**ZONING AMENDMENT
& SUBDIVISION STAFF REPORT****Date: December 19, 2019****APPLICANT NAME**

Downtown West Subdivision, Unit 1, Resubdivision of Lot 13

LOCATION758 Downtown Boulevard and 4312 Midmost Drive
(West side of Downtown Boulevard, 130'± North of Midmost Drive, extending to the North side of Midmost Drive, 275'± West of Downtown Boulevard)**CITY COUNCIL
DISTRICT**

Subdivision approval to create 1 lot from 2 legal lots, and Zoning approval to rezone the site from B-2, Neighborhood Business District, and B-3, Community Business District, to B-3, Community Business District.

SITE PLAN

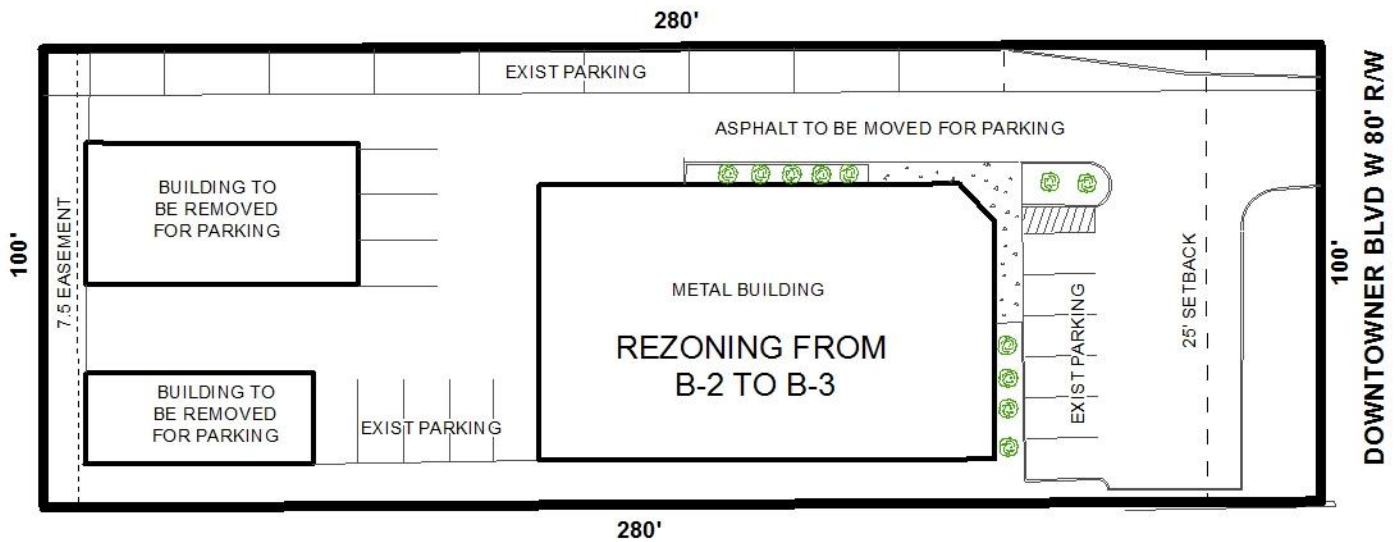
The preliminary plat does not depict the 25-foot minimum building setback line along either street frontage, as required by Section V.D.9. of the Subdivision Regulations. Therefore, the plat should be revised to depict and label the required setbacks on the Final Plat, if approved.

The preliminary plat appears to depict an easement of some sort splitting the proposed lot. The easement is not labeled to identify the type of easement. The original plat recorded in 1967 indicates that it is a 7.5 foot wide drainage and utility easement. The preliminary plat should be revised to label all existing easements on the Final Plat, if approved.

- 1) Revision of the plat to depict and label the 25-foot minimum building setback along both street frontages, per Section V.D.9. of the Subdivision Regulations;

- 2) Revision of the plat to depict and label all easements that exist on the property;
- 3) Retention of all right-of-way width and street name information;
